SUBJECT: Transmittal of Westinghouse Responses to US NRC Requests for Additional Information on the AP1000 Application for Design Certification

AP1000 DESIGN CERTIFICATION REVIEW

Response to Request For Additional Information

**Figure 440.43-10 AP1000 Multiple (5 Tubes) SGTR with Stuck Open SG Safety Valve
Tube Rupture Break Flow**

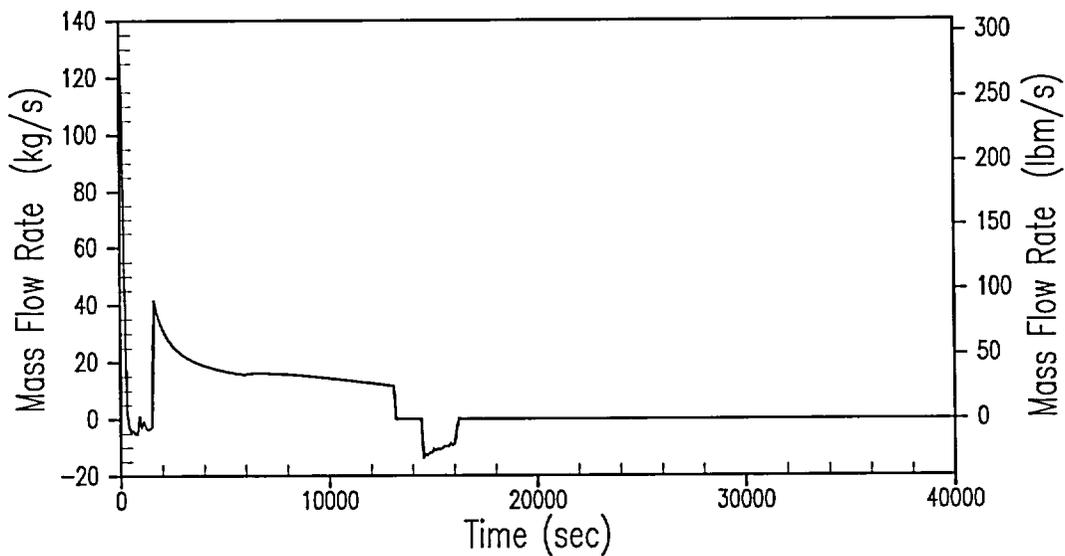
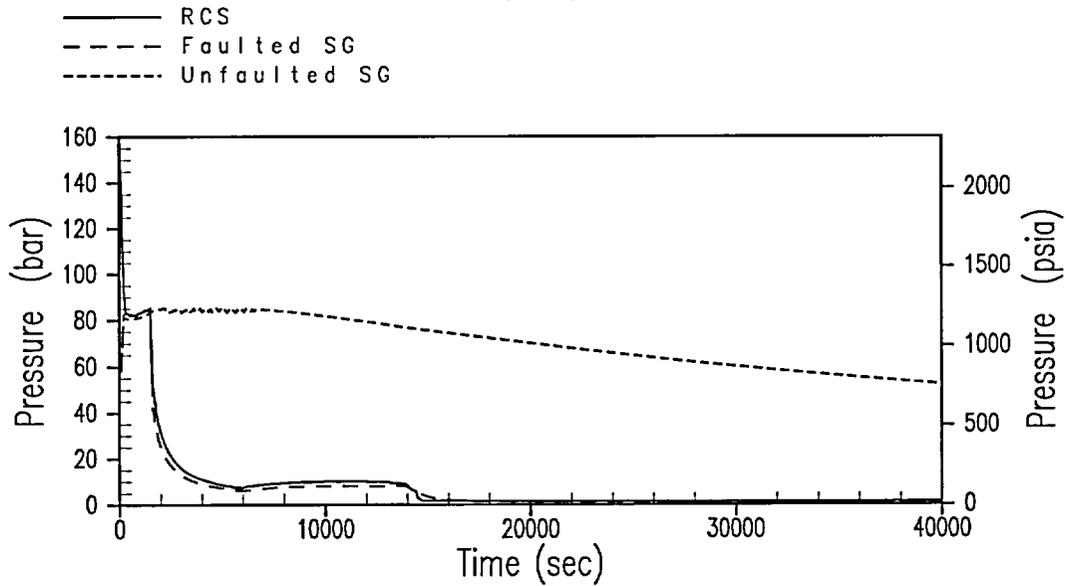
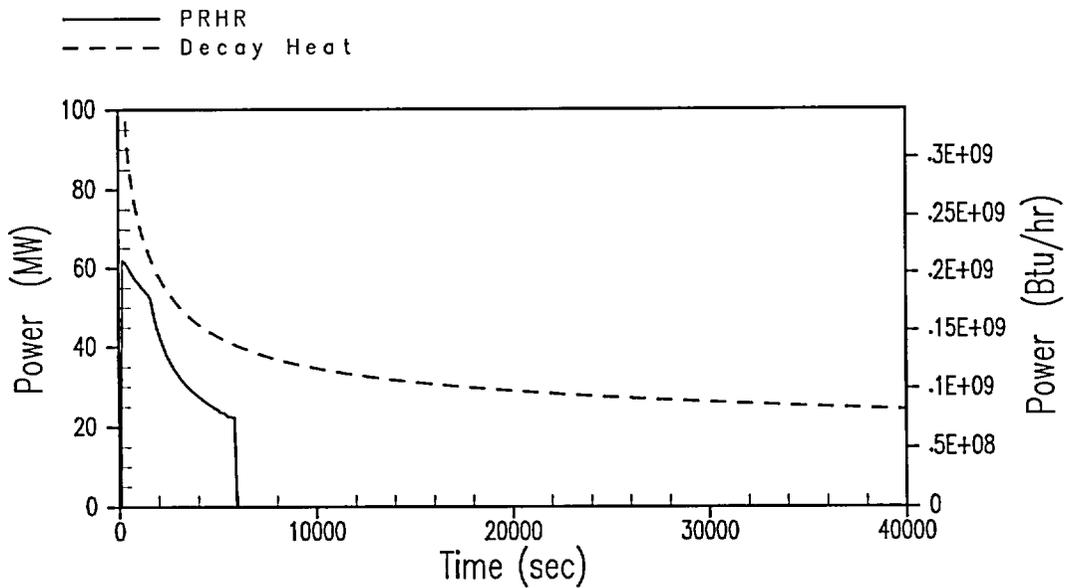
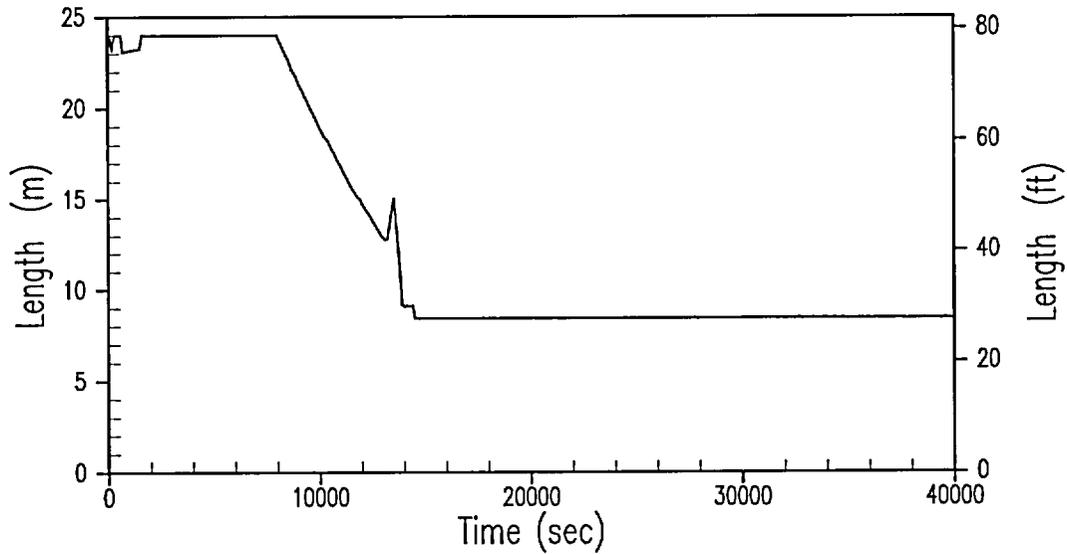
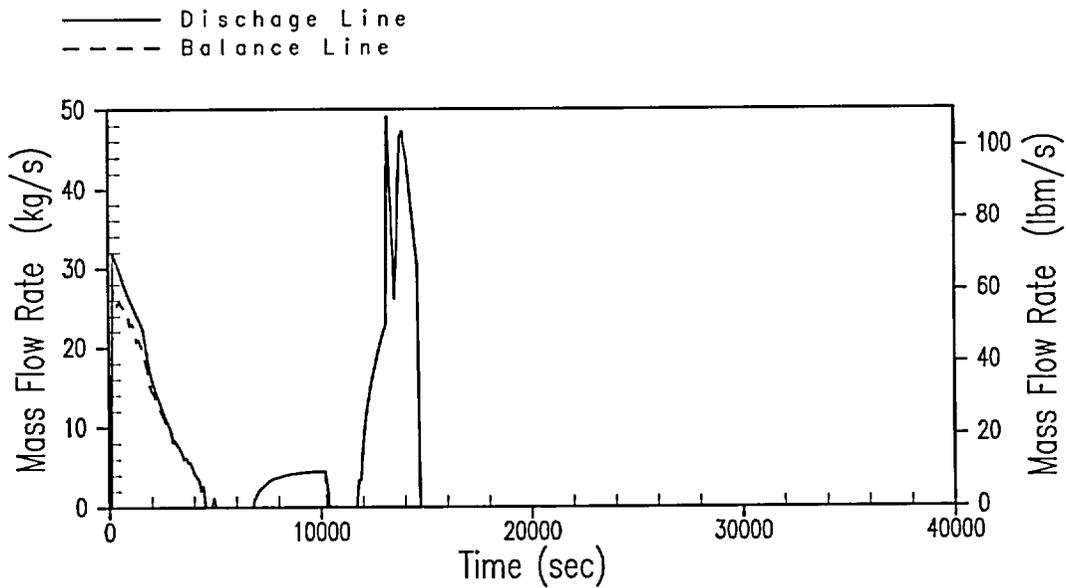
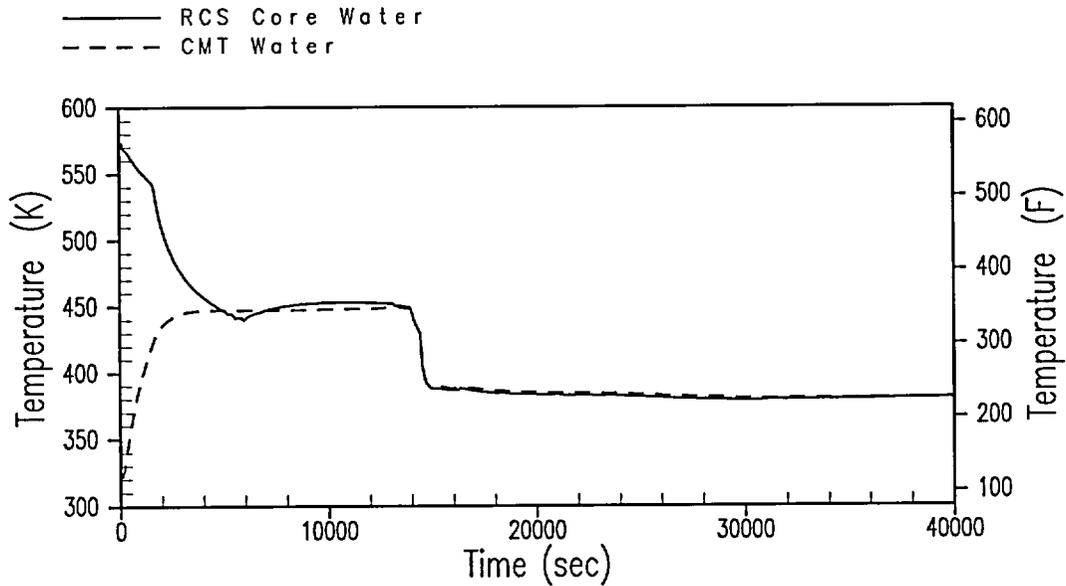
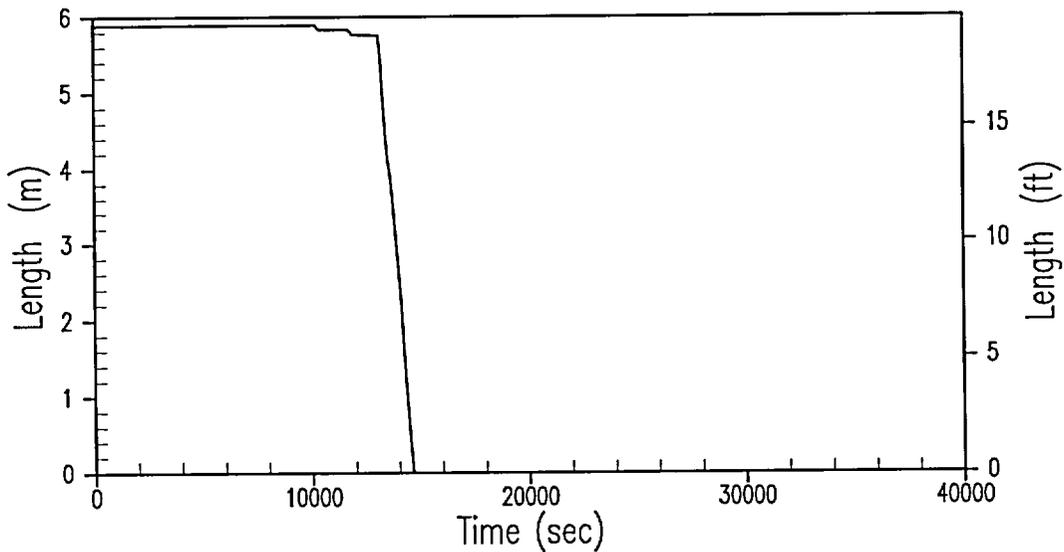
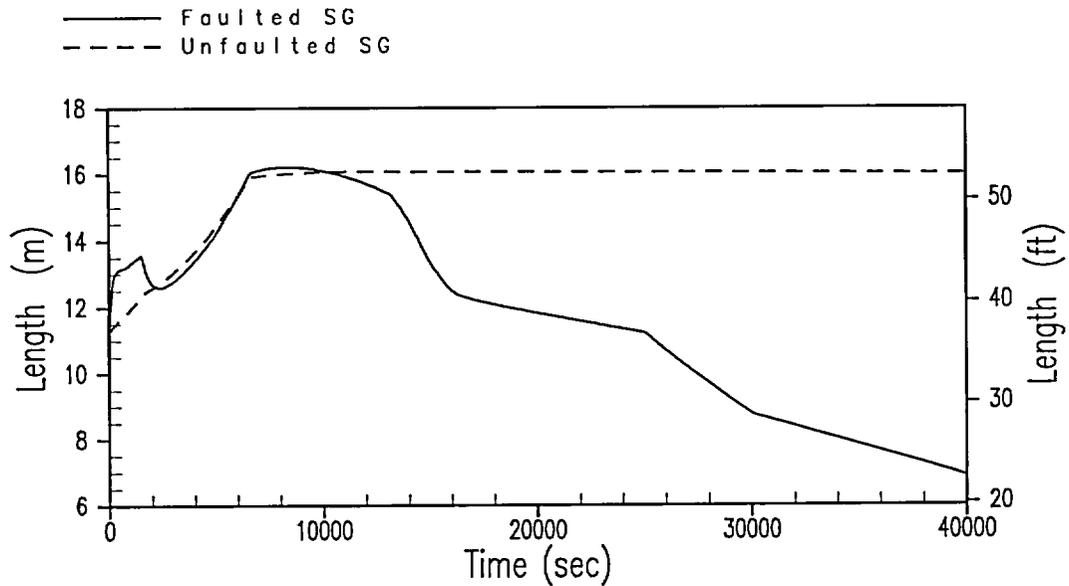
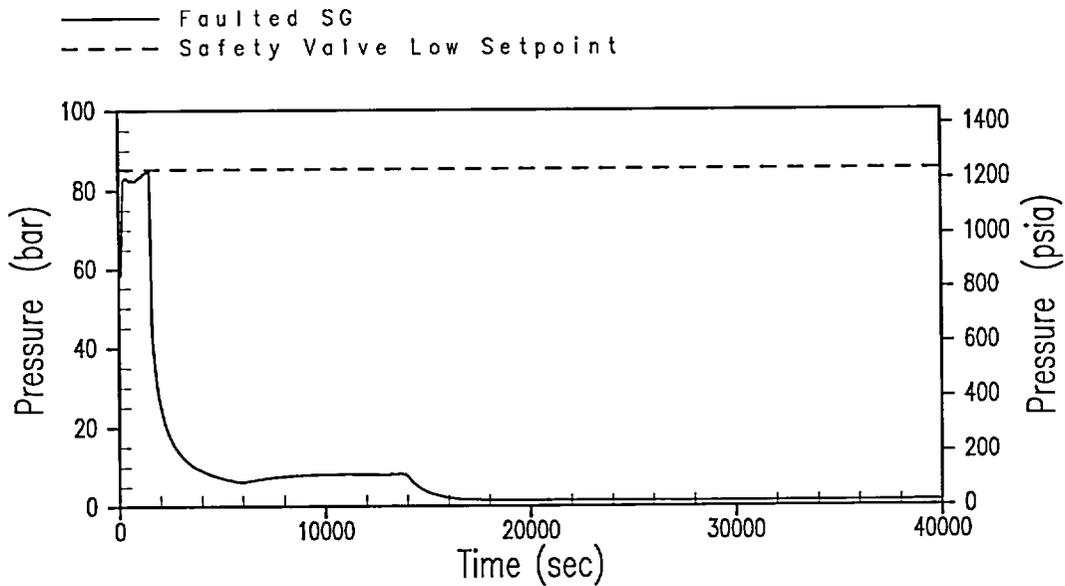
- A. Discuss the AP1000 design features that mitigate or prevent SGSV challenges during an event of rupture of multiple steam generator tubes.
- B. Provide an analysis of multiple-tube rupture events to address the concern of containment bypass leakage resulting from a potential failure of the SGSV to reclose.

The MAAP4 results for case STK are presented in Figure 440.43-10 through 440.43-18. The loss of coolant from the RCS eventually drains the CMTs to the ADS actuation setpoint. The RCS depressurizes and gravity injection begins. The core remains covered and cooled, thus no significant fission product release occurs. Boron dilution due to secondary system water ingress in the RCS during depressurization is not a problem because the PXS injection tanks (CMTs, Accumulators and IRWST) provide boron to the RCS and because boron collects in the secondary system prior to ADS (reference 1). Therefore, the boron concentration of the water coming back into the RCS is expected to have approximately the same boron concentration as the water in the RCS.

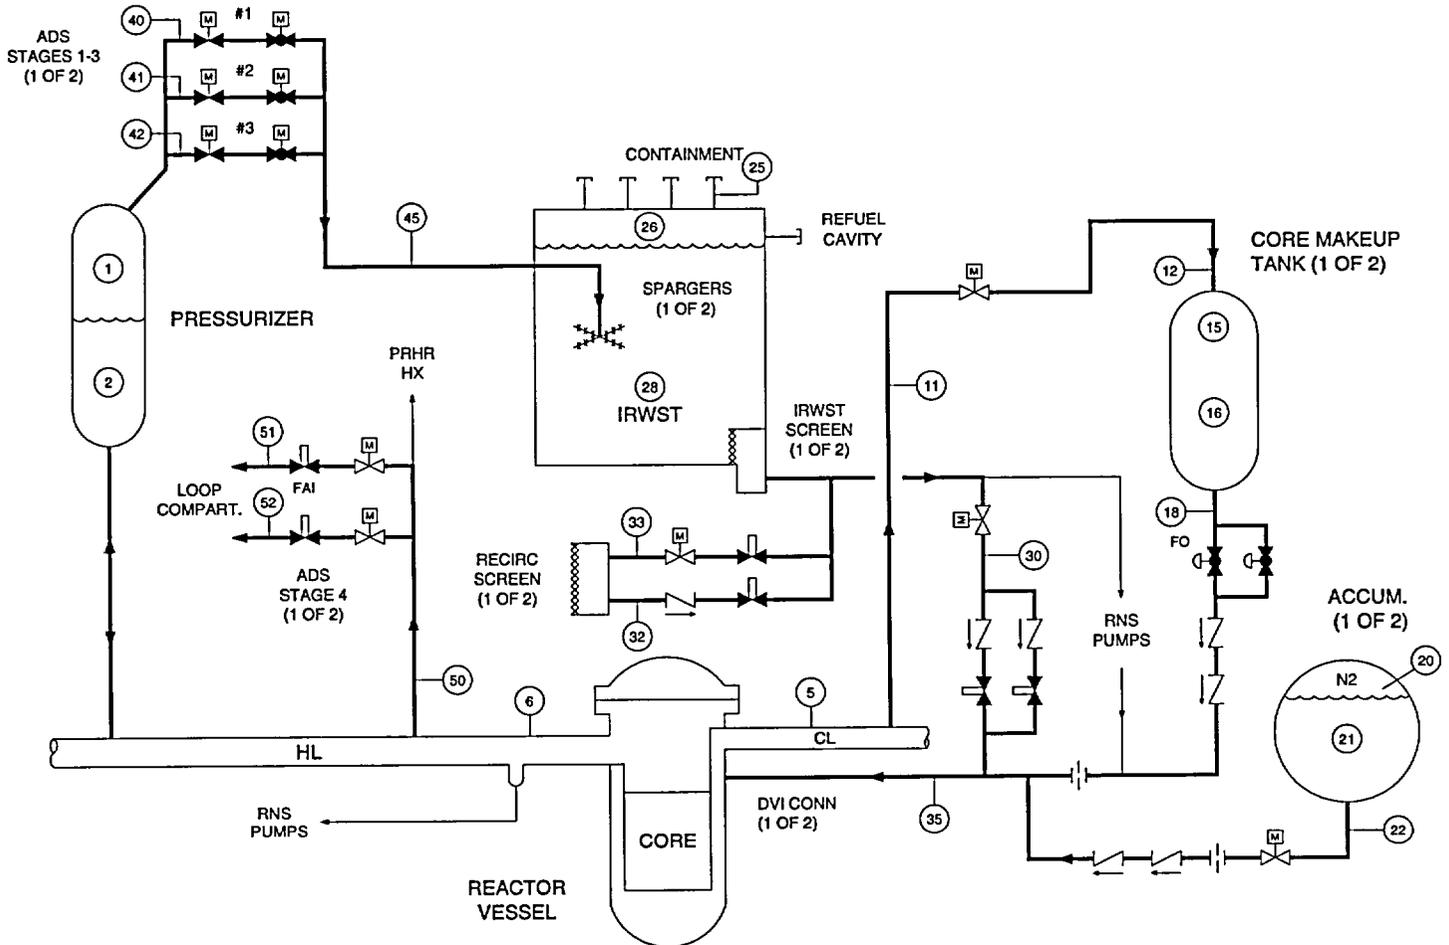
The response to RAI 440.050 explained the reason for not having an flow-adjusting orifice in the IRWST injection line. However, design control document (DCD) Figure 6.3-3 still shows an orifice in the IRWST injection line (Figure 6.3-2 does not show a flow orifice).

The DCD Figure 6.3-3 will be revised to delete the flow tuning orifice in the IRWST injection line.

DCD Figure 6.3-3 will be replaced with the following figure.

Figure 650.004-1 AP1000 IRWST Plan View

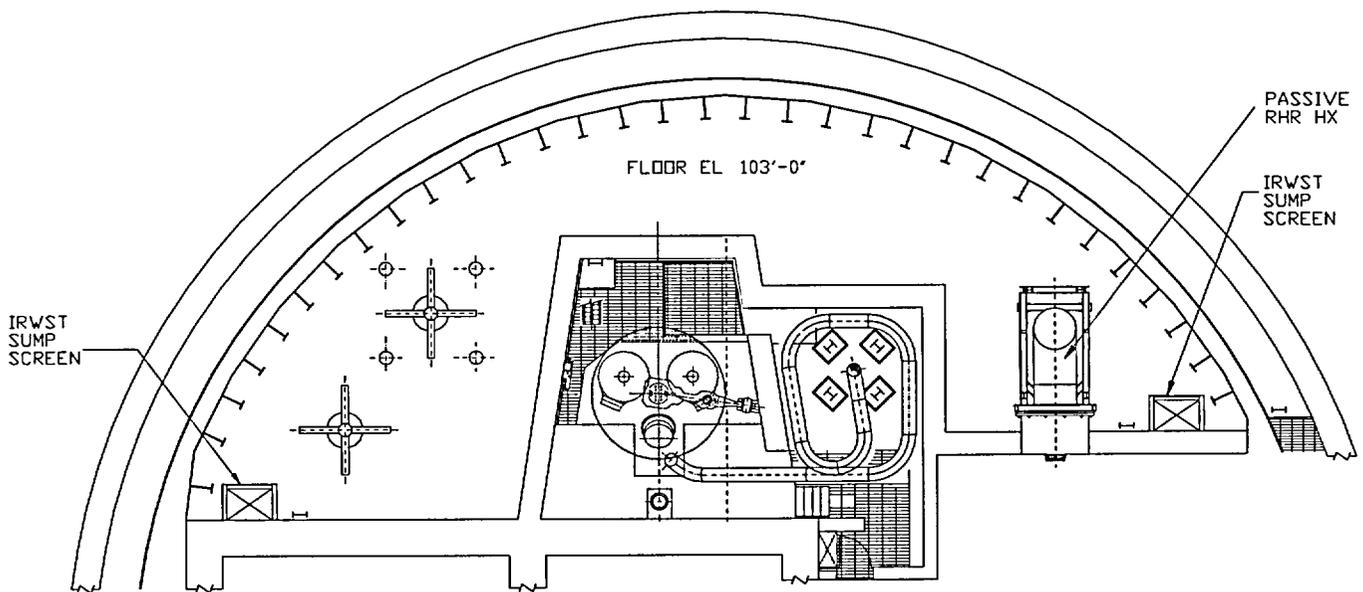
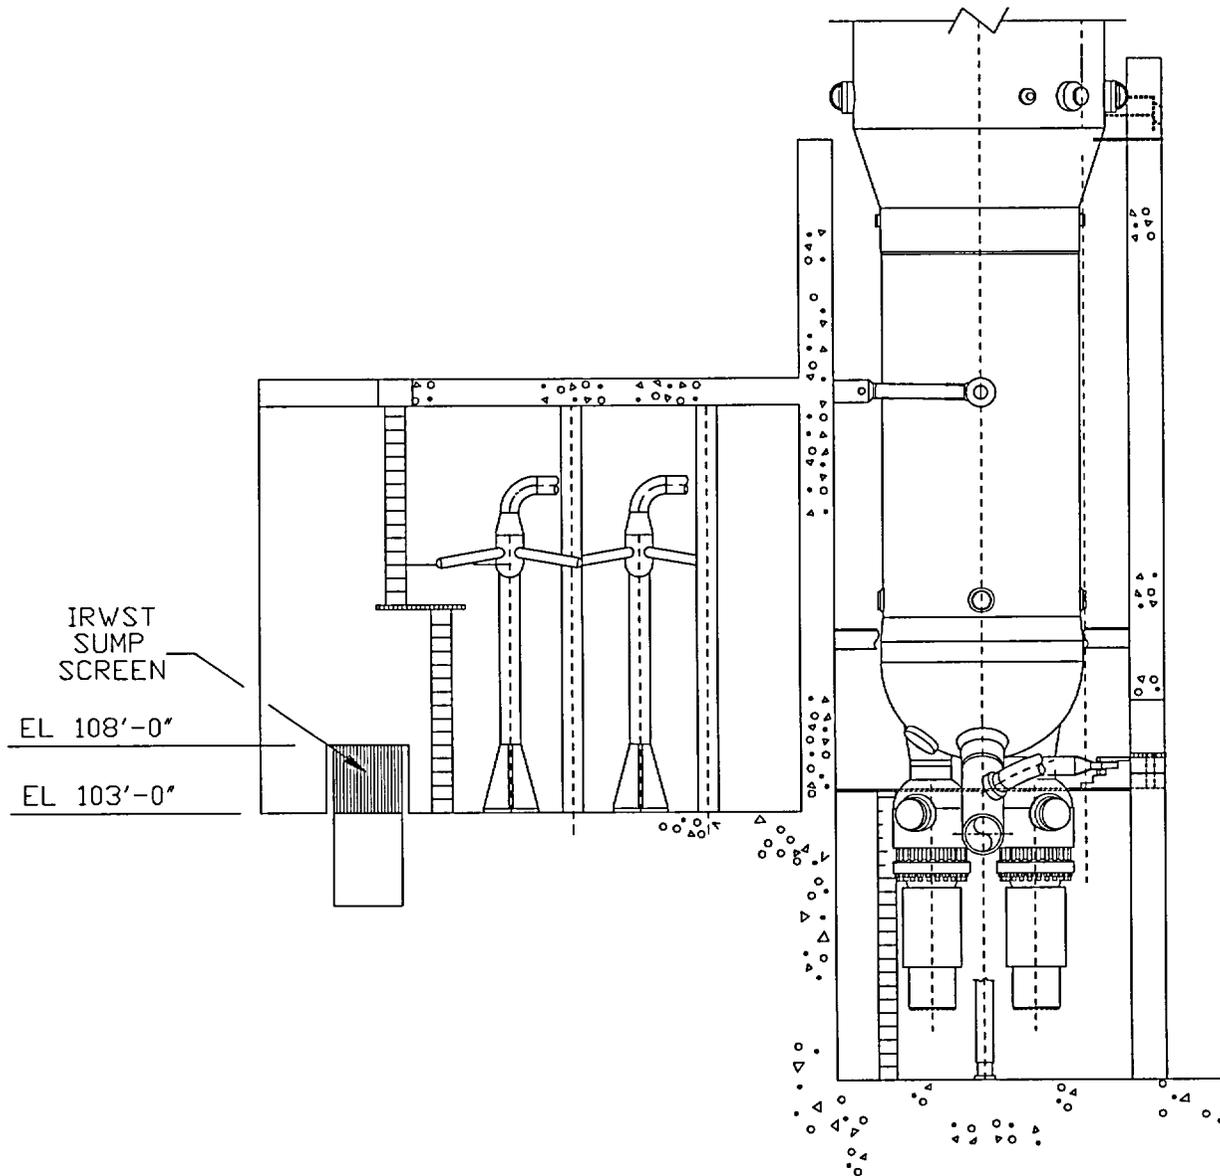
Although the NRC's GSI-191 research program has indicated that fire barriers consisting of fibrous material may generally contribute a smaller volume of LOCA-generated debris than fibrous insulation materials, for the AP1000 (which does not employ fibrous insulation in destruction zones), fire barriers could conceivably contribute a significant fraction of the overall quantity of fibrous material generated by a LOCA. In Section 9.5.1.2.1.1, entitled Plant Fire Prevention and Control Features, the DCD states that [c]omplete fire barrier separation necessary to define a fire area is not provided throughout the primary containment fire area...,and that [s]elected cables of a safety-related division which pass through a fire zone of an unrelated division are protected by fire barriers. The staff could not determine from the DCD (a) whether the fire barriers referred to in Section 9.5.1.2.1.1 would consist of fibrous material, and (b) whether these fire barriers would be located in a zone of destruction for a postulated pipe rupture. Please provide this additional information.

The IRWST is a stainless steel lined storage tank located inside containment. Refer to Figure 650.004-1 and -2. The tank is normally closed off from the containment although there are large louvered vents located through the IRWST roof. The tank is 30.25 feet high (inside floor to ceiling). The tank extends around part of the containment from the refueling cavity past the pressurizer and is about 120 feet across. There are two ADS spargers located in one side of the tank. The bottom of the sparger arms are located about 16 feet above the floor of the tank. There are two separate PXS injection line connections from the bottom of the IRWST. Line A is on the ADS side and line B is on the other side with the PRHR HX. Each of these lines is protected by a screen assembly. Line A has a connection to the Spent Fuel Pool Cooling System (SFS) pumps. This line allows the SFS to recirculate the water in the IRWST to provide cooling and purification as desired; the SFS recirculation flow returns to the IRWST in the PRHR HX side of the tank. This SFS can also be used to transfer IRWST water to and from the refueling cavity. Line B has a connection to the Normal Residual Heat Removal System (RNS). This line allows the RNS to recirculate the IRWST for purposes of mixing and cooling. Line B can be used to allow the RNS to provide long term post ADS core cooling via containment recirculation. The RNS does not use this line to provide short term low pressure injection; the RNS can provide this function using the SFS cask loading pit as a source of water.
